RESPONSES TO
NRC QUESTIONS
ON THE
MONTICELLO PUAR

PREPARED BY
NUTECH ENGINEERS, INC.
SAN JOSE, CALIFORNIA

PREPARED FOR
NORTHERN STATES POWER CO.

NRC QUESTION ON MONTICELLO PUAR
HYDRODYNAMIC LOAD RESPONSE

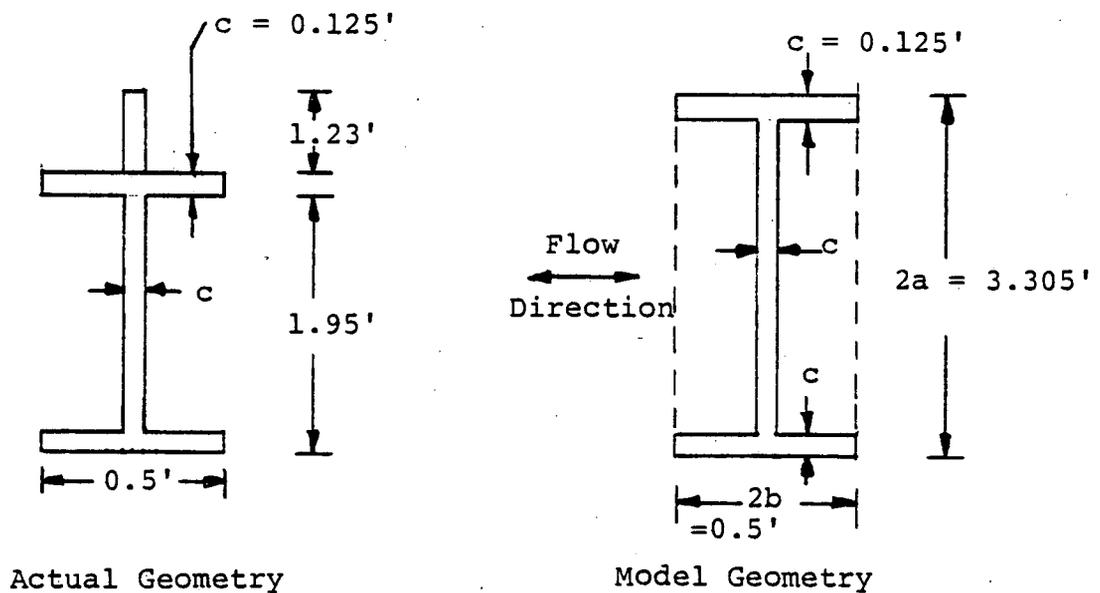
ITEM 1: Acceleration volumes for the ring girder submerged structure loads (Sections 1.4.1.5, 1.4.1.6, 1.4.1.7.3, 1.4.1.8.3, 1.4.2.4 and Appendix A) are computed by an alternate method that differs from the Acceptance Criteria. The stated use of Table 1-4.1-1 is clearly not possible directly as the shapes and flow directions presented do not match any realistic model of the ring girder. The information presented in Appendix A is insufficient to determine the general conservatism of the alternate method. For segments 7, 8, 9 and 10 (Figure 2-2.2-9) give the specific procedures for calculating the acceleration volumes for loads in the directions normal to the flange, normal to the web and normal to the stiffeners. For the post-chug example chosen in Appendix A identify the chugging downcomers and the phasing selected, and give the local accelerations at segments 7, 8, 9 and 10 in the x, y and z directions due to unit source strengths that were used to generate Table 2-2.2-9.

The acceleration drag volume for the ring girder was initially calculated following the method described in NUREG-0661 for structures with sharp corners, such as I-beams. That is, a cylinder is circumscribed and the volume is based on the cylinder. The SRV air bubble drag pressure calculated with the ring girder idealized as a cylinder was approximately 187 psi. (in-plane direction). However, the highest bubble pressure measured during the T-Quencher test at Monticello was 14 psi. Subsequent investigation of this discrepancy revealed that the acceleration volume based on a circumscribed cylinder was extremely conservative. An empirically derived volume was then estimated as follows.

The model that predicts torus shell pressures due to SRV actuations (QBUBS02) was used to calculate the peak pressure at the ring girder location and then this pressure (12.2 psi) was compared to the one derived from the submerged structure model (187 psi) results. The ratio of these pressures gives the value by which the ring girder acceleration volume based on an equivalent cylinder should be divided to yield realistic results. Note that this value is still conservative since QBUBS02 was calibrated to bound all test data.

When the acceleration volume for the ring girder based on the equivalent cylinder is divided by the ratio just described, the value obtained is approximately equal to that presented in Appendix A of the Monticello PUAR.

When the acceleration volume in the out-of-plane direction for the ring girder is calculated conservatively by modeling the ring girder as a rectangle, a value of 50.46 ft³ is obtained for Sections 7 through 10. This value is calculated as follows:

$V = [1.187 \pi a^2 + (2a-2c) + 4cb] LA_w$ where the dimensions a, b, and c are shown above, L is the segment length (2.36') and A_w is the wall interference factor (2.0).

$$V = 50.46 \text{ ft}^3$$

The value of the acceleration volume presented in Appendix A of NSP PUAR is 8.50 ft³. Thus, if the more conservative value is used, the submerged structure loads would be 5.94 (=50.46/8.50) times higher.

Figure 3-1
RECTANGULAR CELL MODELING FOR PLANTS WITH 96 DCS
C.O. AND CHUGGING (CELL A)

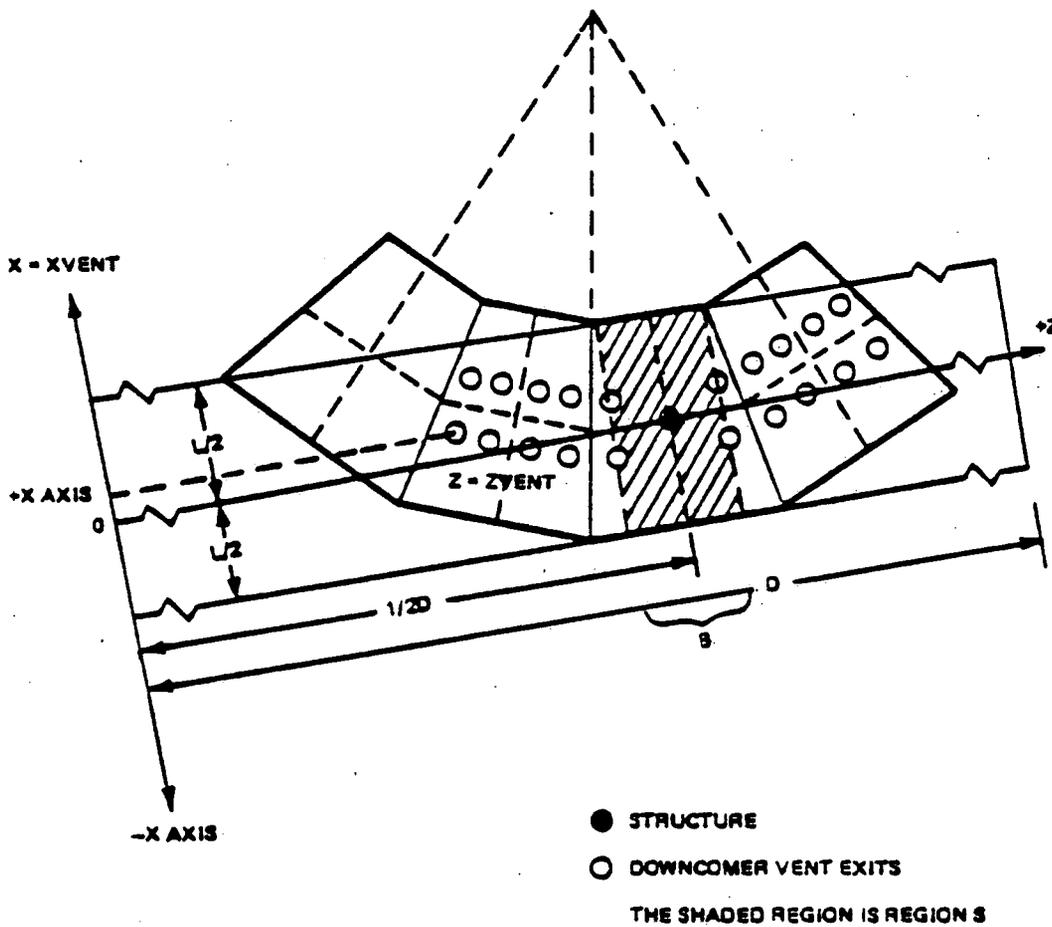
ITEM 3: Submerged structure loads require a computation of the velocity and acceleration fields computed on the basis of the method of images applied to a model of the torus bay. Table 1-4.1-2 gives the relevant parameters for the rectangular bay model used for LOCA bubble drag loads. Is the same model used for CO, chugging and SRV loads on submerged structures? If yes, justify the use of this model for structures near the bay boundary (e.g. ring girder, vent header support column) under asymmetric loading conditions, i.e., sources acting in one bay only. If not, describe in detail the models used.

The rectangular bay model for CO, chugging and SRV loads on submerged structures is similar to that used for LOCA bubble drag loads.

As required in Appendix A of NUREG0661, Model E in NEDE-21983-P is used for the method of images simulation of the torus cross-section for LOCA air bubble, CO, chugging and SRV analyses.

The length of the bay model for LOCA air bubble analysis is equal to one actual bay and structures may be close to the bay boundary.

However, for the CO, chugging and SRV analyses, structures are always placed at or very near the center of the rectangular bay model ($\frac{1}{2}D$) as shown in Figures 3-1, 3-2, 3-3, and 3-4. From these figures it can be seen that the torus is unwrapped to a length D which is equal to the torus circumference ($D = 2\pi R_{\text{major}}$, $D_{\text{Monticello}} \approx 308\text{ft}$). Hence, structures are never near the bay boundary and asymmetric loading conditions, i.e., sources acting in one bay only, are readily accommodated.
